NUCLEAR REGULATORY COMMISSION

ALLEGATION NUMBER - RI-91-A-0315

PLANT DESIGN CHANCE REQUEST

NOTICE OF DESIGN CHANGE COMPLETION

SF-327 Rev. 0 Date: 9/1/78 Page 2 of 2

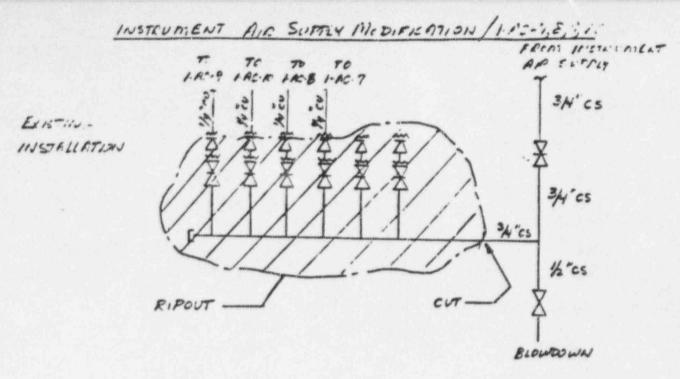
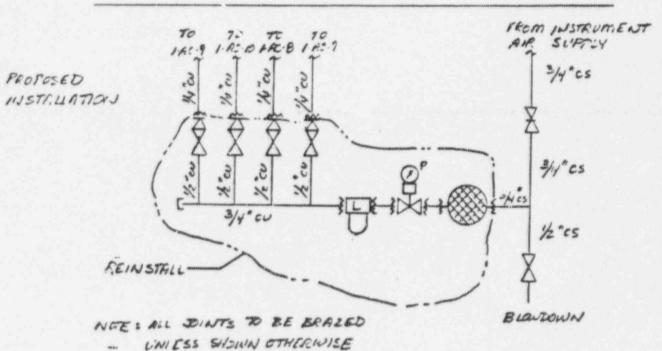
PROPOSED CHANGE INSTALL AN AIR FILTER, REGULATOR,

LUBRICATOR, AND CORROSION RESISTANT PIPING.

AND VALVES IN THE INSTRUMENT AIR SUPPLY LINE

'UPSTREAM OF THE AIR OPERATORS FOR VALVES 1-AC-7, 1-AC-8,

1-AC-9, AND 1-AC-10 (ATMOSPHERIC CONTROL SYSTEM).

REAL I FOR CHANGE RO. # 80-78 I.AC-9, DOCUMENTS VALVE STICKING PROBLEM

FOR VALUE 1-AC-9. SUBSEQUENT INVESTIGATION OF VALVE OPERATORS FOR VALVES 1-AC-9 AND 1-AC-7 REVEALS SIGNIFICANT RUST AND SCALE CARRYOVER PROM INSTRUMENT AIR SUPPLY AS PROBABLE CAUSE OF VALVE STICKING.

2. INSTALLATION OF AN AIR FILTER UPSTREAM OF AIR OPERATORS FOR

1-AC 7,89, AND ID WILL PREVENT RUST AND SCALE CARRYOVER TO OPERATORS.

CORROSION RESISTANT PIPING AND VALVES WILL BE INSTALLED TO ELIMINATE

POSSIBLE CORROSION OF PIPING BETWEEN THE FILTER AND OPERATORS. AN

AIR LUBRICATOR, WILL BE INSTALLED DOWNSTREAM OF THE ARR FILTER TO

PROVIDE CANTINITIES LUBRICATION TO OPERATORS PER MANUFACTURER'S RECOMME

ATIONS. PRESSURE INDICATION WILL BE PROVIDED BY THE BIR REGULATOR. SEE

AC-9 VALVE, THE 2" BYPASS AROUND THE EIGHTEEN INCH VENTILATION EXHAUST LINE FROM THE DRYWELL, HAS FAILED TO OPERATE PROPERTY A NUMBER OF TIMES. CORROSION TYPE DEBRIS WAS FOUND IN THE SOLENOIND VALVE AND OPERATOR.

TO ELIMINATE THIS DEBRIS PROBLEM A FILTER/
REGULATOR/LUBRICATOR HAS BEEN INSTALLED IN THE AIR HEADER FEEDING VALVES AC-7.8,9,10.
